VariMAX Top Housing Replacement

MotorGuide has informed the MotorGuide service network of this issue (through MotorGuide Service Bulletin 2009-07) and they will have all the information needed to perform the necessary service work. MotorGuide will cover the costs of these repairs.

Transom mount motor configuration
a - Black motor lead
b - Red motor lead

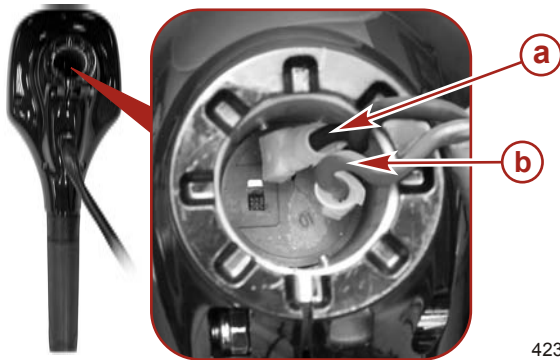
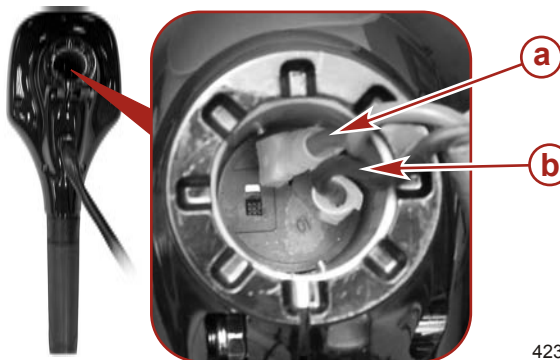
2. With the top housing inverted, connect the motor control wires to the correct terminals as shown.

NOTE: If necessary, use needle-nose pliers to securely connect each motor control wire to the respective terminal.
